PROPOSED NEW HOME

23 ODETTE ROAD - Lot 309 SP296915

PROPOSED SITE PLAN - Lot 309

PLANS AND DOCUMENTS referred to in the PDA DEVELOPMENT APPROVAL

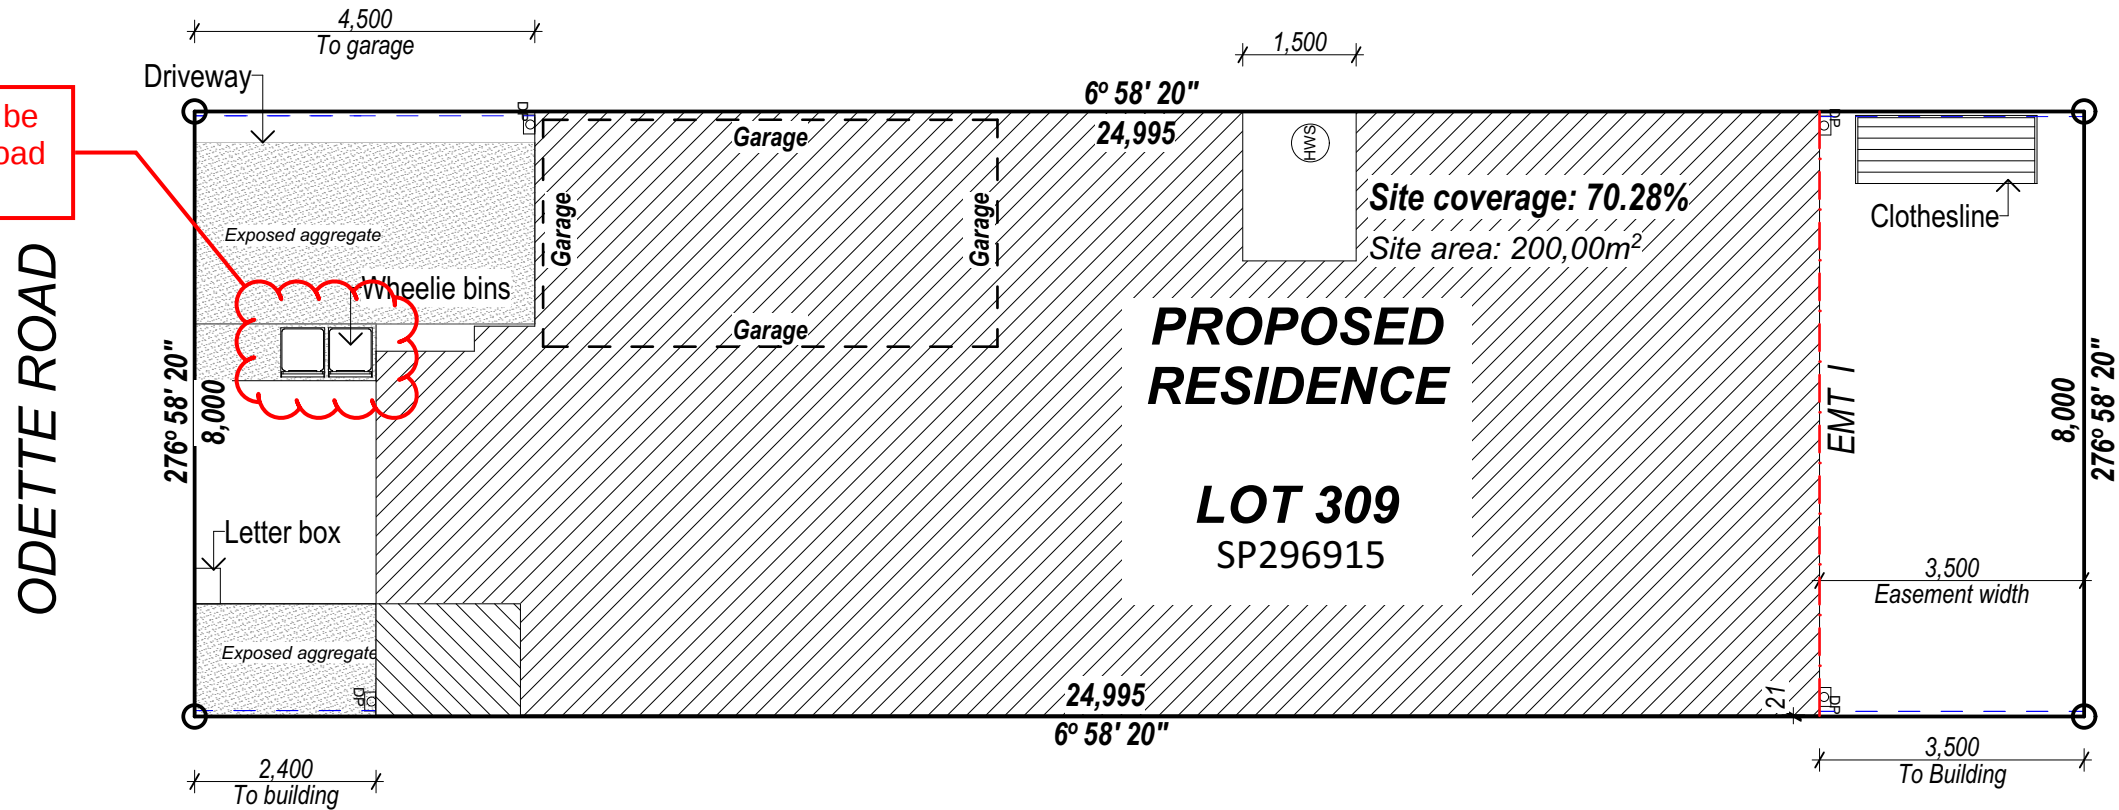
Wheelie bins to be screened from road frontage.

NOTE: Any fencing at the front from front of building to road area will be done in black flat top aluminum pool type fencing.

AMENDED IN RED
